PRODUCT IMPROVEMENT BULLETIN

Electric Step Improvements

Applies to Kwikkee Step Series 22, 23, 24, 25, 26, 28, 30, 31, 32, 33, 34, 35, 36, 37, 38, 39, 40, 42 and 44

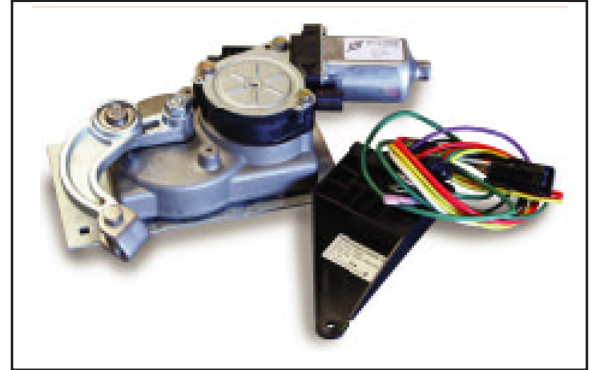
New parts include:

- Linkage and Gear Box
- Motor*
- Control Unit+

The step improvements were made to increase performance, reliability, and longevity of step operation. The changes also simplify parts replacement procedures.

Improved linkage and gear box Investment cast zinc plated steel linkage assembly is strong and more resistant to corrosion. Brass spherical outer cage with hardened ball in linkage is stronger, wears longer, and will not oblong. Improved gear box has fully sealed dual ball bearings for greater efficiency and no maintenance. Case halves seal for consistent alignment and gear protection from the elements.

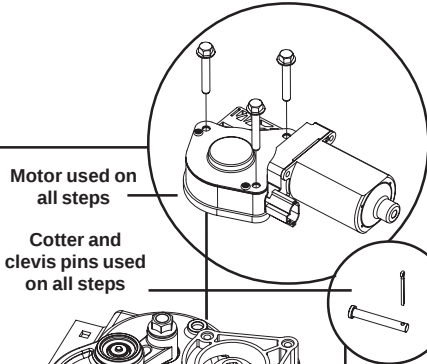
Improved motor 40% more motor torque gives the step a strong lock-out and solid feel.

Improved control unit logic Step is always open when door is open. Step can be locked in the extended position. Step cannot be locked in retracted position. Automatic ignition override makes step follow door.
